**DEVELOPMENT PERMIT STAFF COMMITTEE MEMBERS**

To develop this site with a 13-storey modular apartment building, containing 129 social housing units and parking at-grade accessed from Arbutus Street. The building is targeting Passive House certification.

THAT the Board APPROVE Development Application No. DP-2022-00500 submitted, the plans and information forming a part thereof, thereby permitting the development of a 13-storey modular apartment building, containing up to 129 social housing units with parking at grade accessed from Arbutus Street, subject to the following conditions:

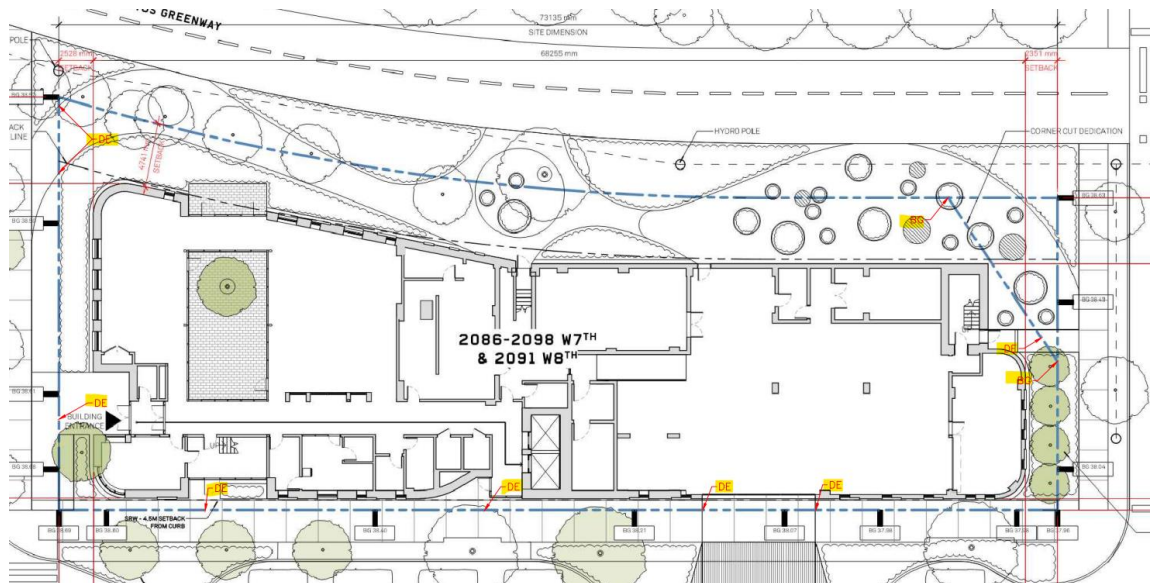
A.2.1 Provision of City issued Building Grades to be shown on the site plan/A1.00/A2.01.

**Note to Applicant:** Building grade elevations are missing from the plan along W. 8th Avenue corner cut dedication.

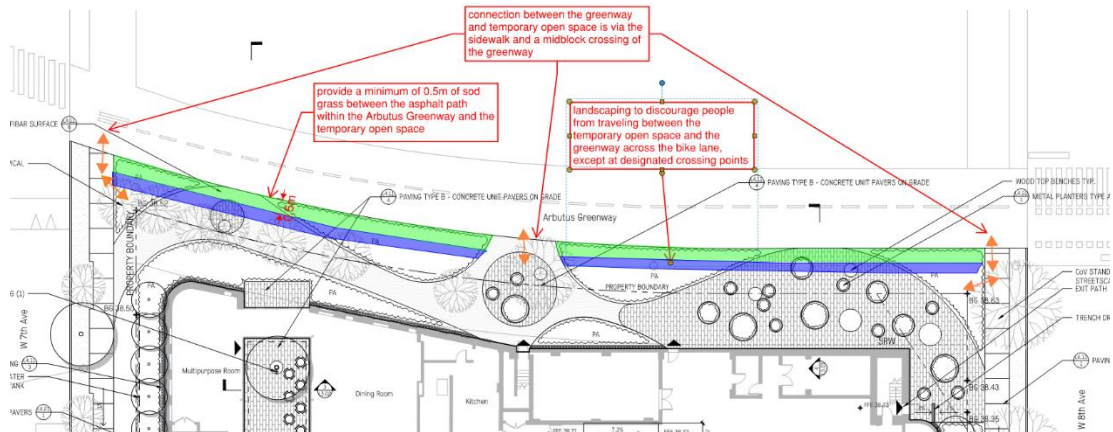
- A.2.3 Provision of City issued Building Grades survey benchmark **Monument V-1628** to be used on the **site plan/A1.00/A2.01**, or provide written confirmation specifying the benchmark denoted on any topographic survey used for design purposes is consistent with the benchmark elevation established on the building grade plan issued by the City.

**Note to Applicant:** Please see building grade letter and markup below for more details:
